**MONTGOMERY COUNTY HISTORIC PRESERVATION COMMISSION**  
**STAFF REPORT**

| <b>Address:</b>    | 2500 Holman Avenue, Silver Spring   | <b>Meeting Date:</b>  | 6/25/2025        |
| <b>Permit No.:</b> | 1097561   | <b>Staff:</b>         | Laura DiPasquale |
| <b>Proposal:</b>   | Construction of two new single-family houses with associated grading, hardscape alterations, and tree removal |                       |                  |

**Figure 8: Proposed site plan submitted for the third preliminary consultation review.**

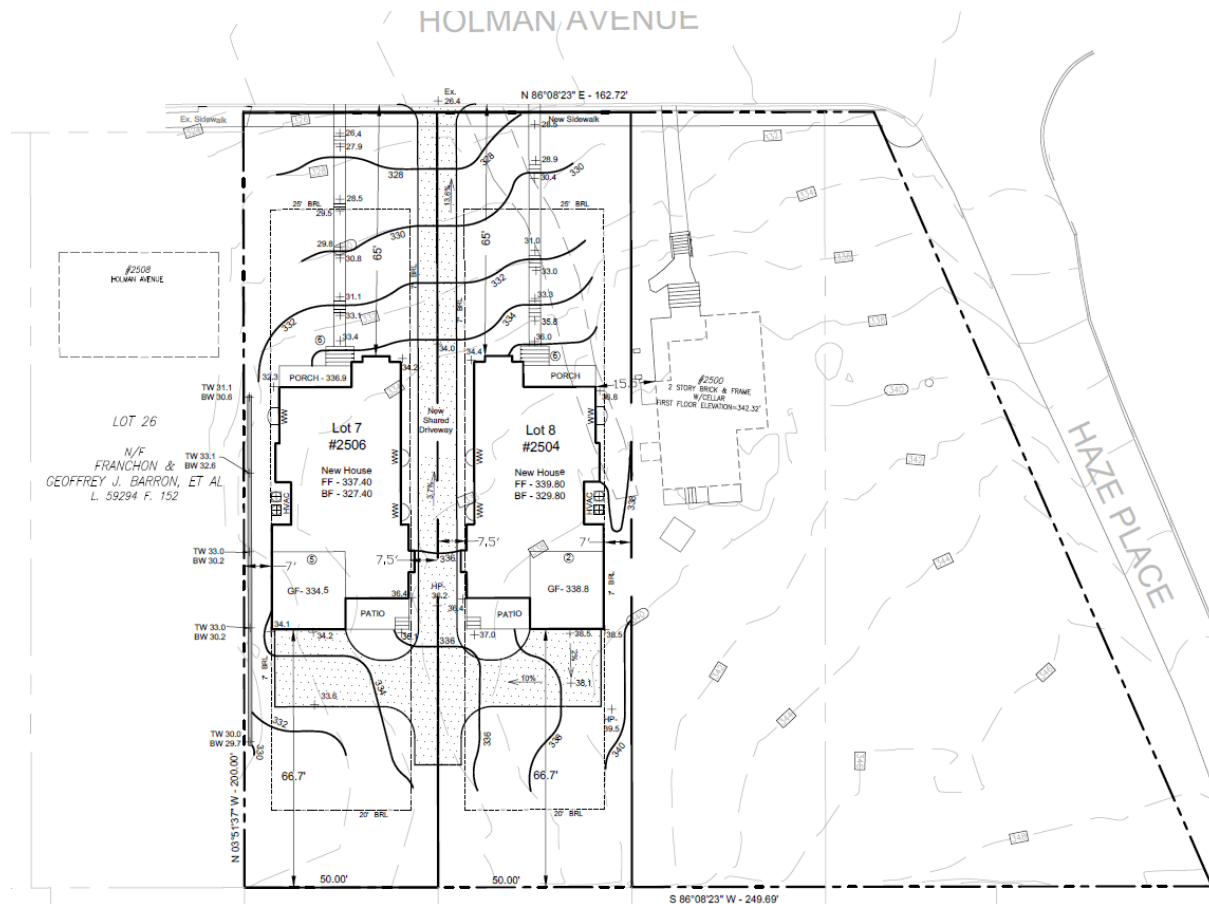
- A distance of 15 feet between the historic house and new construction on Lot 8 is still inadequate but is acceptable owing to the other site and project constraints.

- The proposed height from average grade should be lowered to 35 feet, which will help reduce its conspicuousness and also meet zoning requirements. The height reduction could be accomplished in part by lowering the height of the first-floor level.

- The historic house should be the closest to the street. Commissioners offered varying opinions on the final placement of the proposed houses, and whether the house on Lot 8 should be pushed back 3-8 feet. A straw poll determined that the buildings could be left as-is.

- An updated dimensioned site plan, including grading details, setbacks from the street, property lines, and adjacent buildings, removing references to the sidewalk extension. The sidewalk extension may be submitted in conjunction with adjacent property owner(s) as a separate future HAWP.

*Figure 9: Massing rendering for revised HAWP submission.*

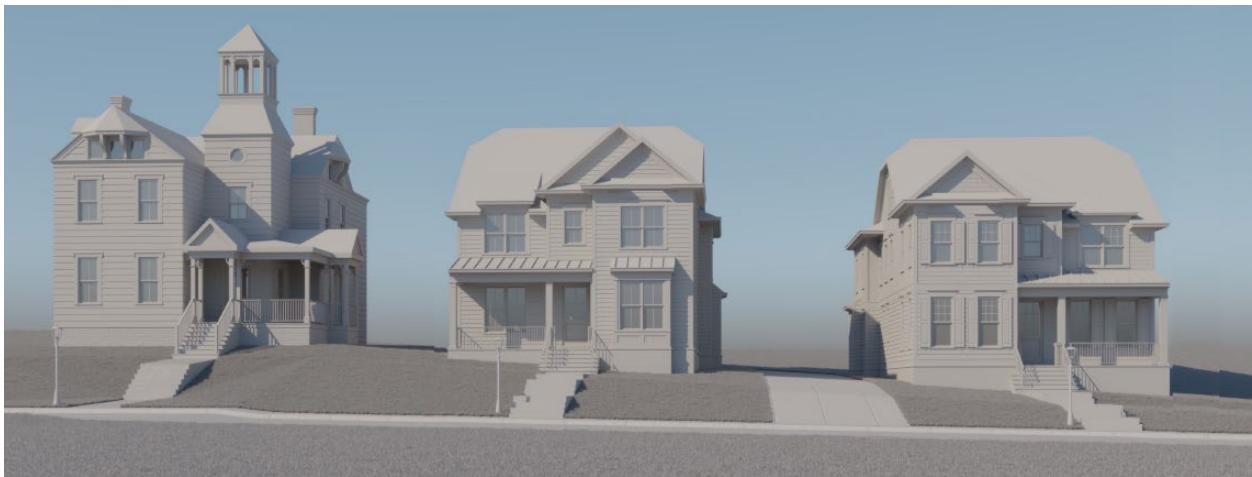
Between the third preliminary consultation review and the current HAWP submission, the applicants have made the following changes:

- Lowered the height of the roof from average grade from 36 feet 8-3/8 inches to 34 feet 7-1/2 inches;
- Removed the occupiable attic loft space, eliminating the third-floor windows and modifying the side elevation fenestration;
- Replaced the gable returns on the nested front gables with closed gables;
- Replaced the metal front porch roofs with asphalt shingle roofs;
- Replaced the stone-clad foundations with brick-clad foundations;
- Simplified the fenestration on the new construction on Lot 7 (2506 Holman Avenue);
- Changed the window line from Andersen 100 series to Marvin Essential fiberglass windows;
- Removed the proposed tree removals on adjacent parcels; and,
- Removed the proposed sidewalk extension.

**Figure 11: Revised front elevations for 2504 and 2506 Holman Avenue.**

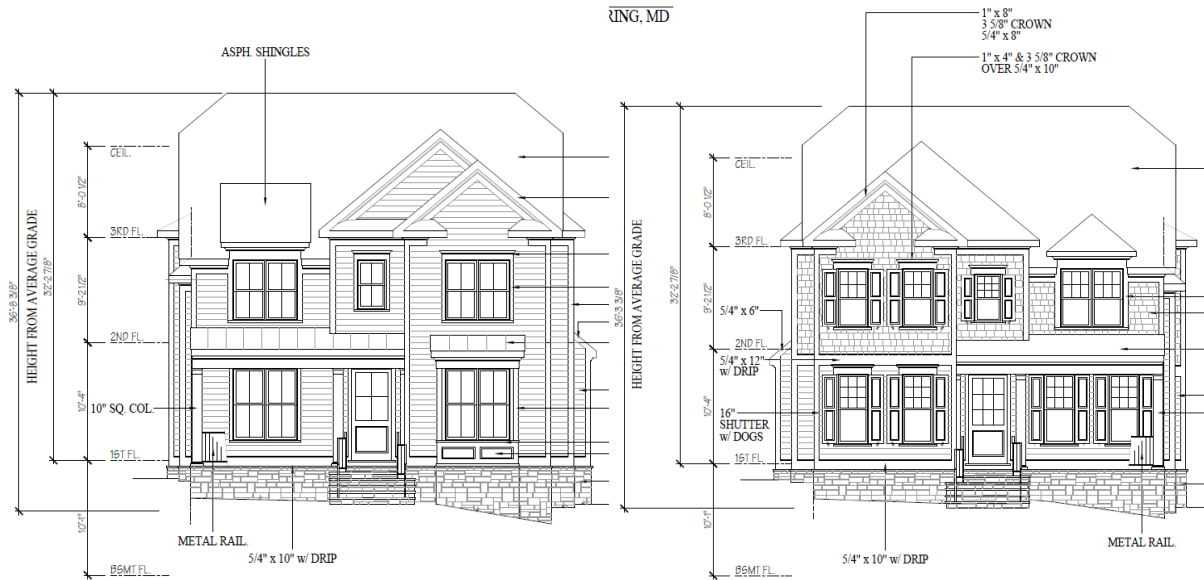
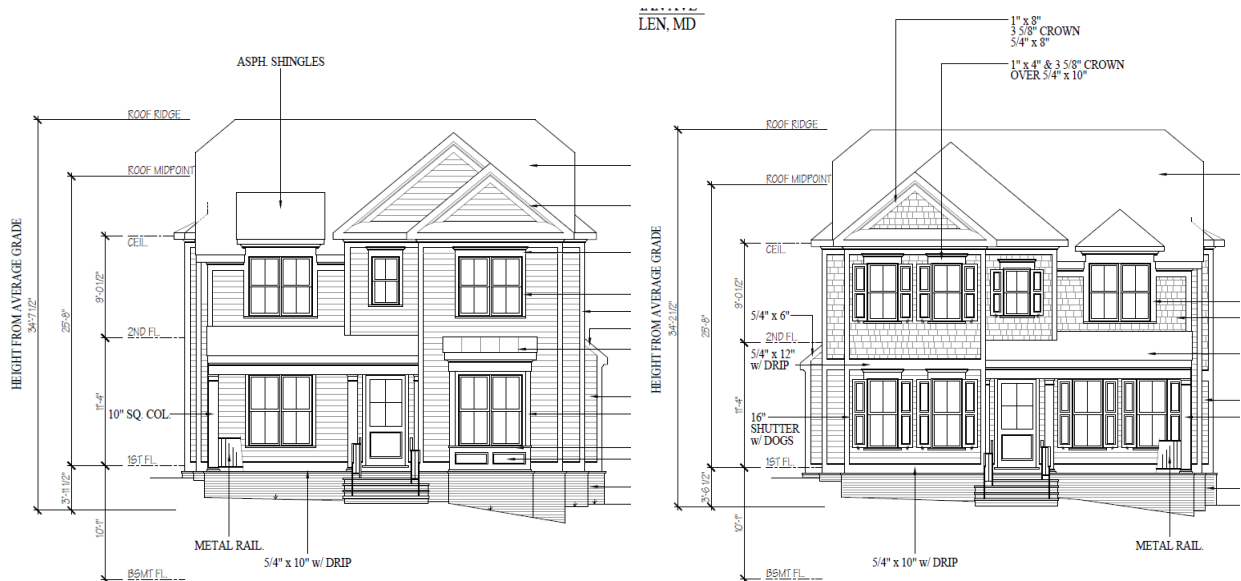
Staff finds that the foundation material change from stone to red brick is consistent and compatible with the district, per Chapter 24A-8(b)(2), as are the proposed Hardie Plank siding and asphalt shingle roofs. Staff continues to find, however, that the proposed Hardie Shake siding proposed on 2506 Holman, which has a .25-inch depth, is overly flat and incompatible in appearance with the historic district, per Chapter 24A-8(b)(2), and recommends that a fiber cement or composite shake siding with a minimum .5-inch depth be utilized. Likewise, Staff finds that the proposed Marvin Essential fiberglass windows, like the previously-proposed Andersen 100 series windows, are overly flat, as can be seen in *Figure 12*, lacking the putty glaze depth of traditional wood windows, and are only available with grilles-between-glass, both details of which Staff finds incompatible for use in a historic district, per Chapter 24A-8(b)(2). Staff recommends the applicants select a more compatible window line with traditional profiles and simulated-divided-lights, such as: Marvin Elevate or Ultimate series; Pella Lifestyle or Reserve series; Jeld-Wen Sitaline or W-5500 series; or Kolbe Ultra or Heritage series. The simulated-divide-light windows should

have 1-1/8 to 1-1/4-inch wide putty slope or beaded muntins, in keeping with the dimensions and proportions of traditional two-over-two divided light windows, per Chapter 24A-8(b)(2) and *Standard 9*.

1. The Marvin Essential line windows are not approved. The new windows must have a traditional sash to glazing profile and simulated-divided-lights with 1-1/8 to 1-1/4 inch putty slope or beaded muntins; no grilles-between-glass. The applicant must provide window specifications, including the proposed muntin detail.
2. The proposed Hardie Shingle siding is not approved. The applicant must submit a specification for a different fiber cement shingle product at least half an inch thick.
3. All standing-seam metal roofing is removed and replaced with asphalt shingles.
4. The applicant must plant a minimum of two new shade trees per property.

METAL ROOF

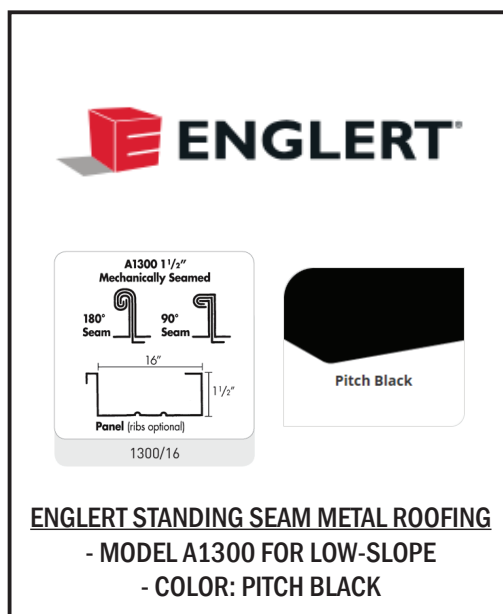
Staff continues to find that the proposed standing-seam metal roofing, which is shown on the front porches in the submission rendering but now only identified on the front bay window of 2504 Holman Ave and rear porches of both buildings in the elevation drawings, should be eliminated and replaced with asphalt shingles.
